Preliminary Submission

Red Oak Trail

Located on Douglas Pike (Route 7)
 Smithfield, Rhode Island
 Assessor's Plat 42 Lot 27, 28 & 36 (Portion)

GRADING PLAN

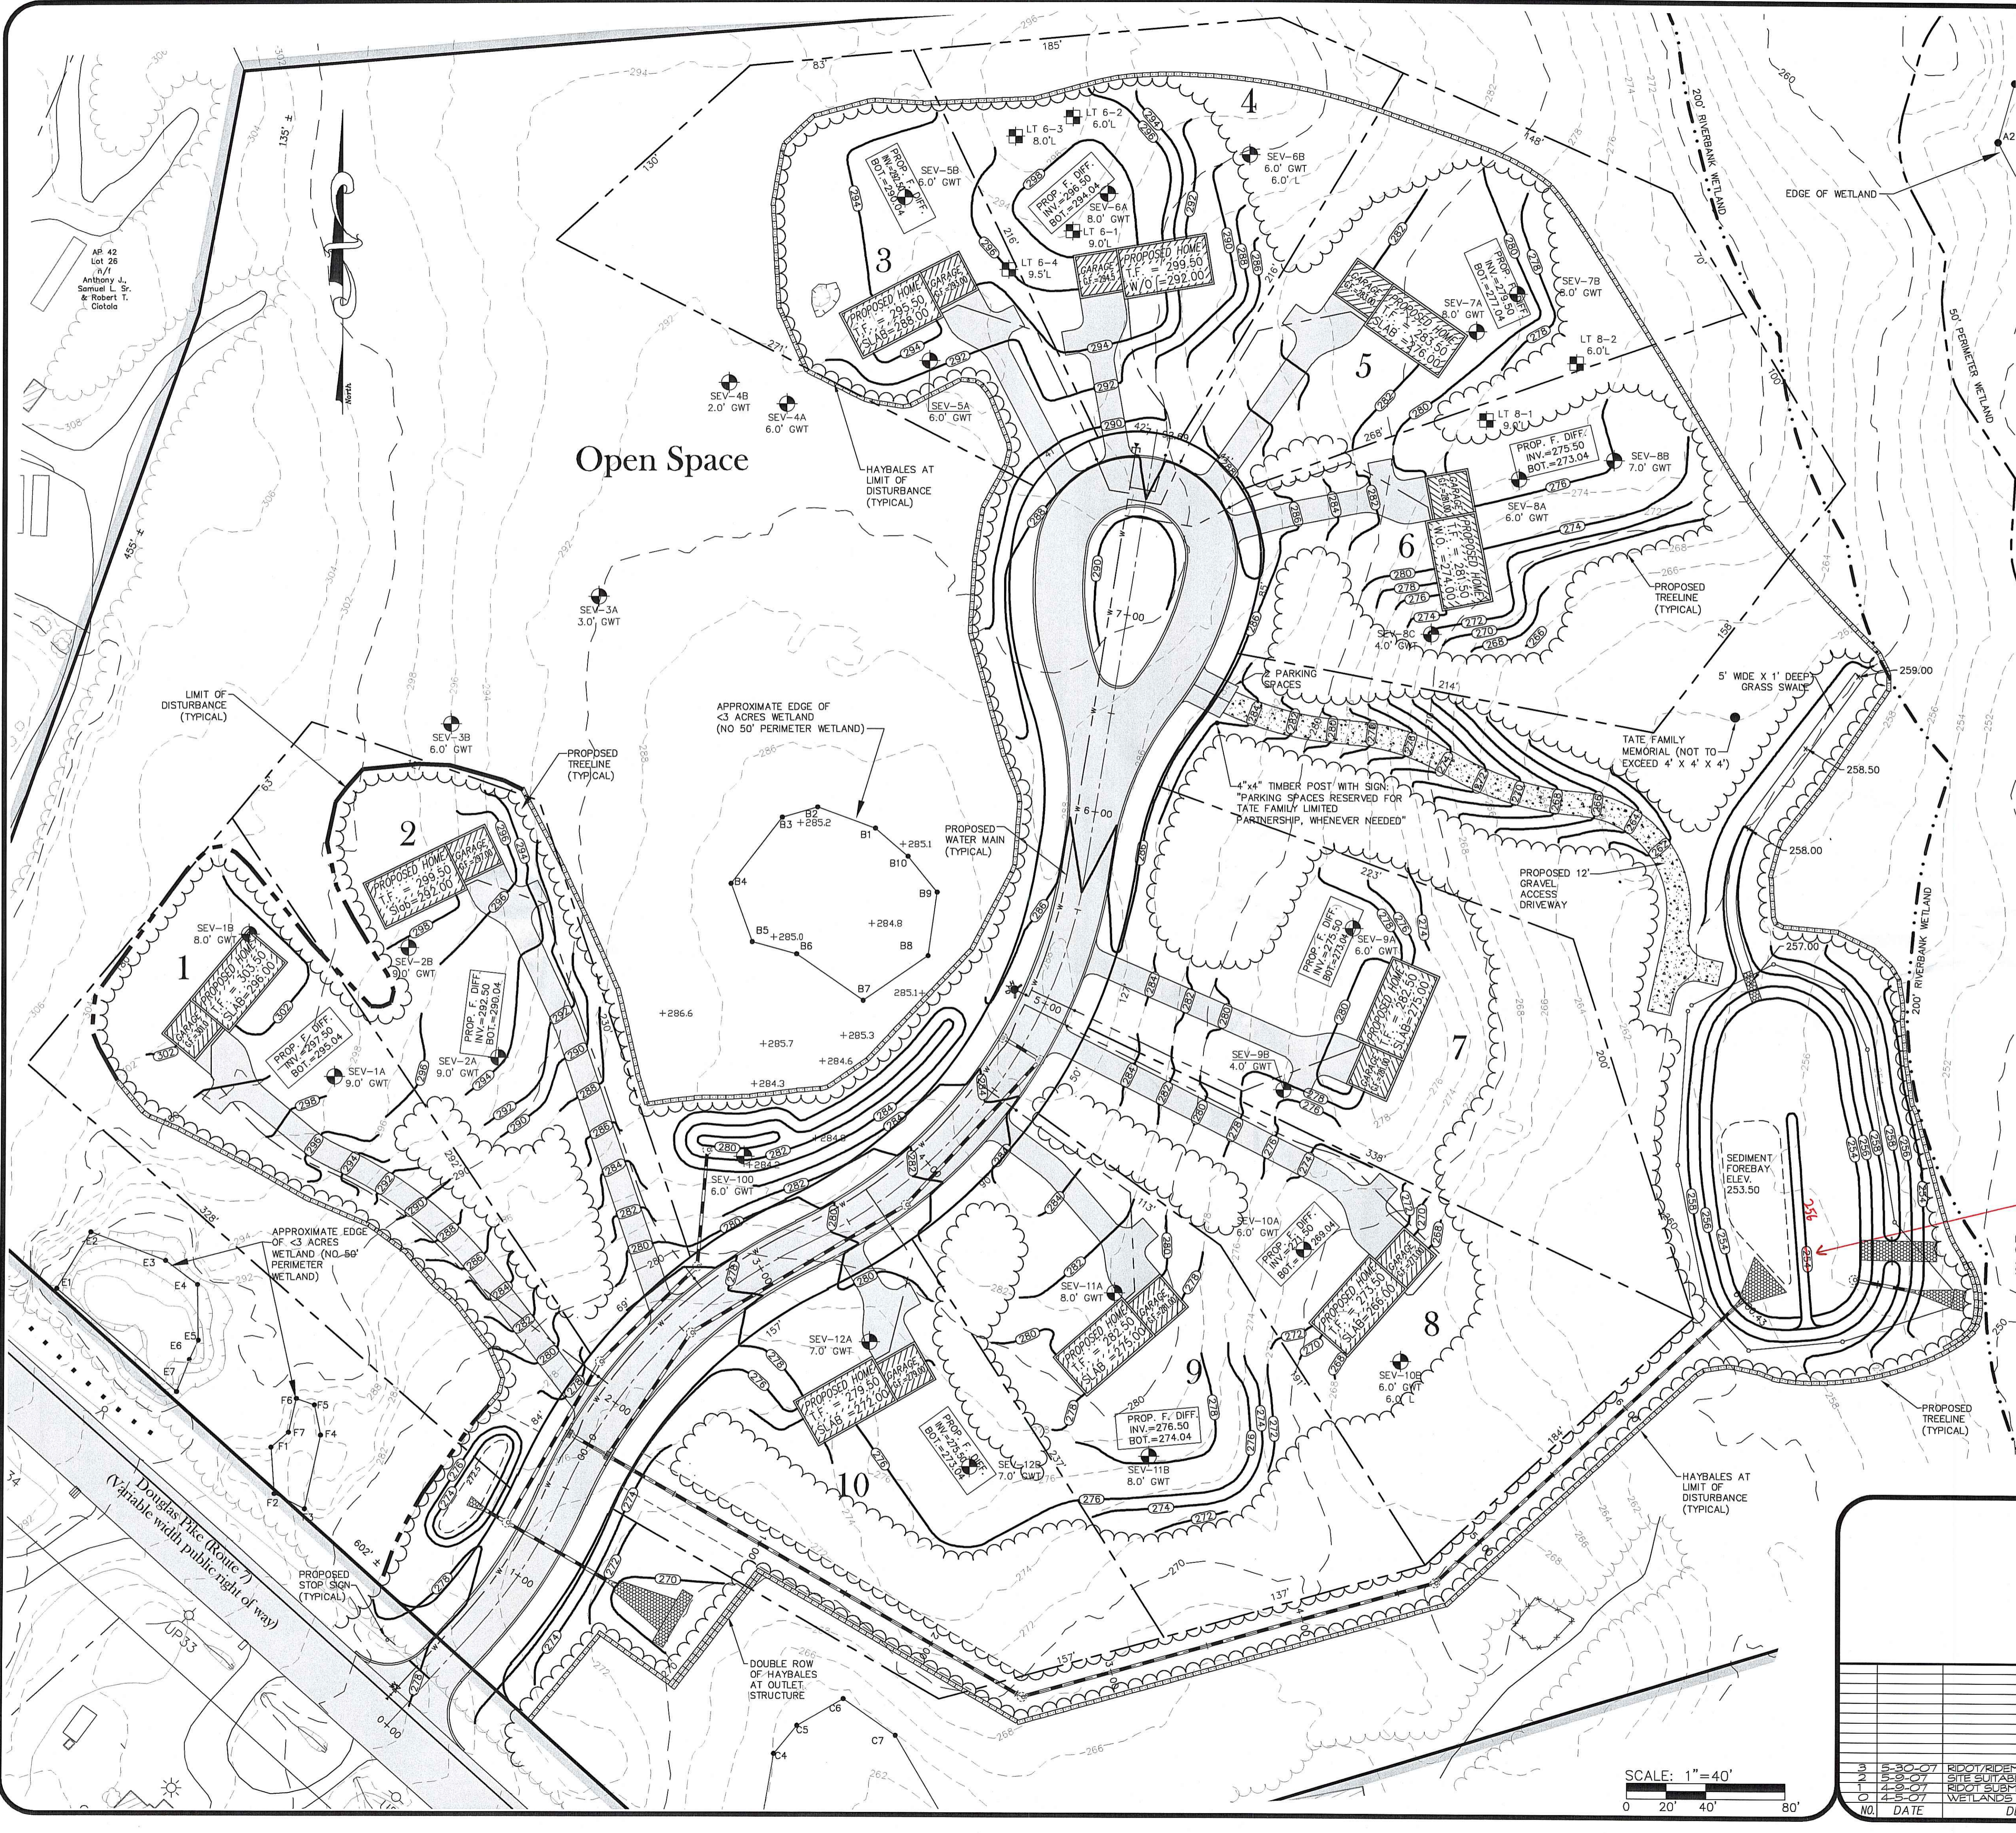
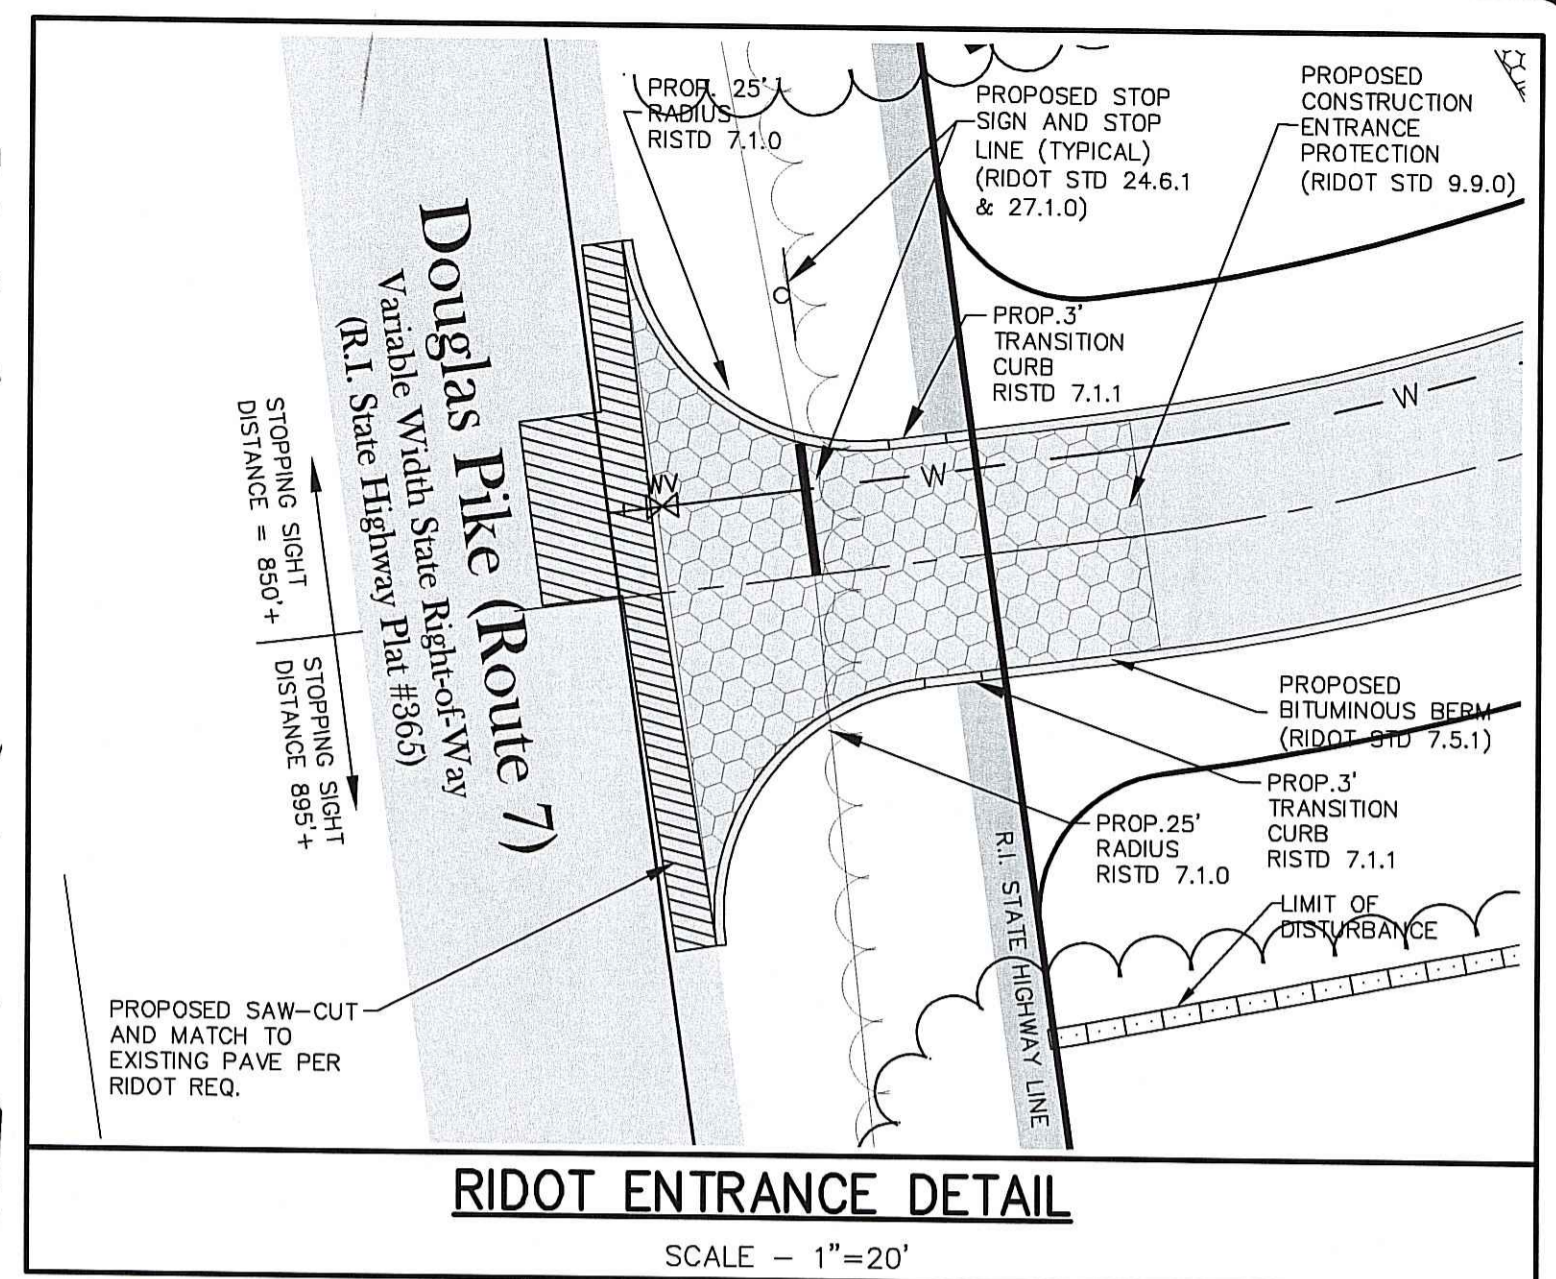
The contour elevation for the interior low term shall be changed to indicate an elevation of 256 per RIDEM.
